APPLICATION NO.	FILING DATE	FIRST NAMED INVENTOR	ATTORNEY DOCKET NO.	CONFIRMATION NO.
10/626,254	07/23/2003	Sebastien Vergnat	034299-531	1025
7:	590 10/06/2005		EXAM	INER
Robert E. Krebs			BAUER, SCOTT ALLEN	
Thelen Reid &	Priest LLP			
P. O. Box 6406	40		ART UNIT	PAPER NUMBER
San Jose, CA 95164-0640			2836	
			DATE MAILED: 10/06/2005

Application No.	Applicant(s)					
	10/626,254	VERGNAT ET AL.	(m)				
Office Action Summary	Examiner	Art Unit					
	Scott Bauer	2836	•				
The MAILING DATE of this communication appears on the cover sheet with the correspondence address Period for Reply							
A SHORTENED STATUTORY PERIOD FOR REPLY THE MAILING DATE OF THIS COMMUNICATION. - Extensions of time may be available under the provisions of 37 CFR 1.13 after SIX (6) MONTHS from the mailing date of this communication. - If the period for reply specified above is less than thirty (30) days, a reply - If NO period for reply is specified above, the maximum statutory period w - Failure to reply within the set or extended period for reply will, by statute, Any reply received by the Office later than three months after the mailing earned patent term adjustment. See 37 CFR 1.704(b).	66(a). In no event

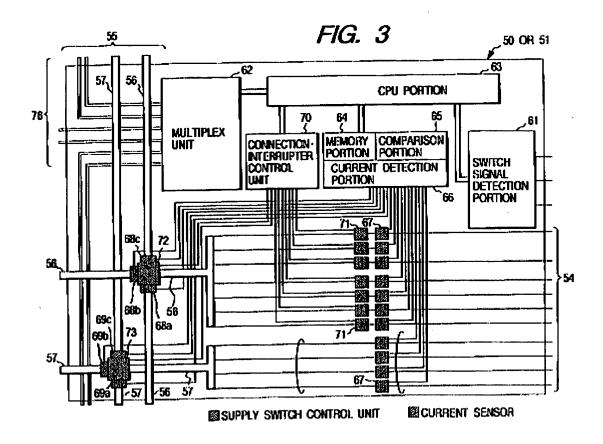
1. Figure 1 should be designated by a legend such as --Prior Art-- because only that which is old is illustrated. See MPEP § 608.02(g). Corrected drawings in compliance with 37 CFR 1.121(d) are required in reply to the Office action to avoid abandonment of the application. The replacement sheet(s) should be labeled "Replacement Sheet" in the page header (as per 37 CFR 1.84(c)) so as not to obstruct any portion of the drawing figures. If the changes are not accepted by the examiner, the applicant will be notified and informed of any required corrective action in the next Office action. The objection to the drawings will not be held in abeyance.

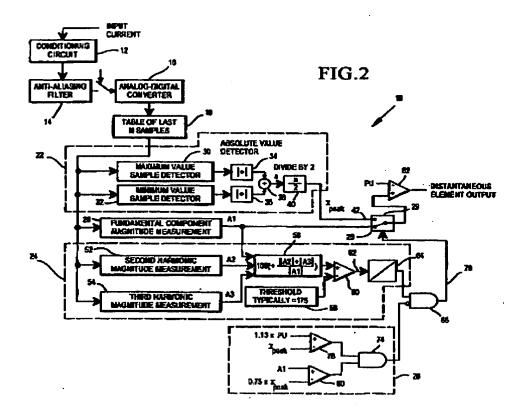
4. With respect to Claim 1, Matsumaru et al. in Figure 3, discloses a device for protection against over-currents in an electrical energy distribution cabinet (50), which receives electrical energy supplied by at least one generator (47) and which distributes this energy to at least two loads connected to 54, which comprises: switching means (70-72), means for calculating (66) the absolute value of the difference between at least one current entering the cabinet and at least one corresponding current leaving the said cabinet, for at least one harmonic of these currents (66, 67, 68a,b,c & 69a,b,c), comparison means (65) which control the opening of the switching means if this absolute value is greater

than a predetermined threshold (61, 65 & 70). This comparison between the current values would inherently require a predetermined threshold.

10. With respect to Claim 3, Matsumaru et al. teaches the invention set forth above and further teaches that the calculating means determining the difference between the current coming from a generator and entering the cabinet and the sum of the currents leaving this cabinet corresponding to the loads supplied by this generator (Fig. 3, 66-69).

11. With respect to Claim 4, Matsumaru et al. teaches the invention set forth above and further teaches that the second calculating means (65) determining the difference between the set of currents entering the cabinet and the set of currents leaving the cabinet (Fig 3. 65).
